# Office Action Summary

The following correspondence is a non-final Office Action for application # 10/585,454, entitled: DRIVE FOR ADJUSTING MOTOR VEHICLE SEATS, filed on 08/04/2006.

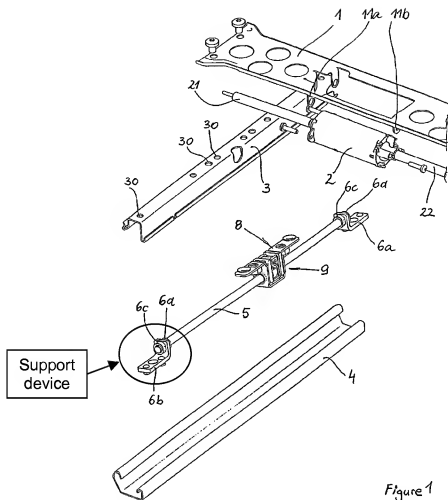
Regarding claim 1, Taubmann discloses a drive having a spindle **5** that is attached to first **4** of two rails **3**, **4** that are adjustable relative to one another by means of support device (as shown in Fig. 1 below) located on at least one end of spindle **5**, and having gear mechanism **9** driven by motor **2**, which is arranged on second rail **3**. Taubmann fails to teach where at least one support device has a trough-shaped outer support surface in which one end of the spindle is seated in a fixed manner. The Examiner notes that the spindle's attachment to the support device is merely an alternative method of fastening the elements together. The claim would have been obvious because the substitution of one known element for another would have yielded predictable results to one of ordinary skill in the art at the time of the invention.

With regards to claim 2, Taubmann teaches the drive, characterized by two such support devices (see Fig. 1 below) being provided, whereby one of such support devices **60** serves to hold one of two ends of spindle **5** in each instance.

With regards to claims 23-25, Taubmann teaches the drive, characterized by spindle **5** that is seated firmly on support device(s) forming a pre-assembled module together with lower rail **4** and upper rail **3**, where the lower rail **4** being releasably connected with support device(s), and further characterized by lower rail **4** and support devices being connected with one another in a form-fit manner (as shown in Fig. 1).

Figure 2

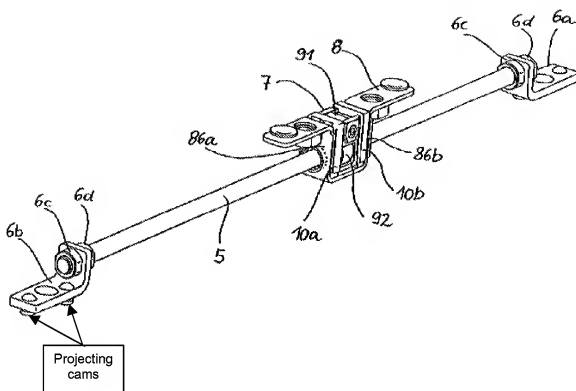
With regards to claims 15 and 16, Taubmann teaches the drive, characterized by support device having no less than one projecting cam (as shown in Fig. 2 below) on its lower support surface for engaging into corresponding opening of first rail **4**, and where the two cams are spaced apart from one another when seen in the longitudinal axis to spindle **5**.

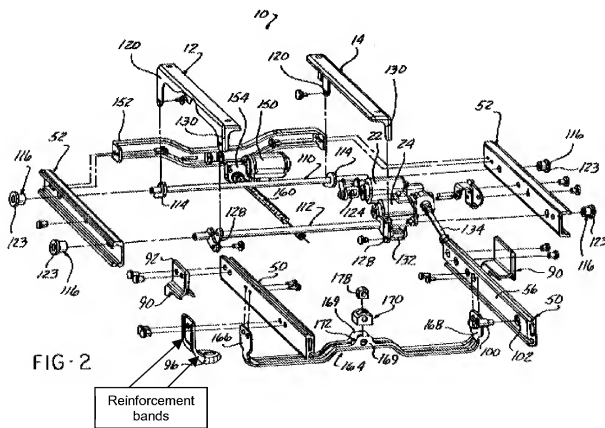
Taubmann is discussed above, and fails to teach reinforcement bands. Gauger teaches an L-shaped support member **96** with reinforcement bands (as shown in Fig. 2 below), formed in one piece on the border side at the inner transition area to the horizontal shank. It would have been obvious to one having ordinary skill in the art at the time of the invention, to incorporate the reinforcing bands of Gauger with the support device of Taubmann, in order to provide additional stability for the support device, as is well known in the art.
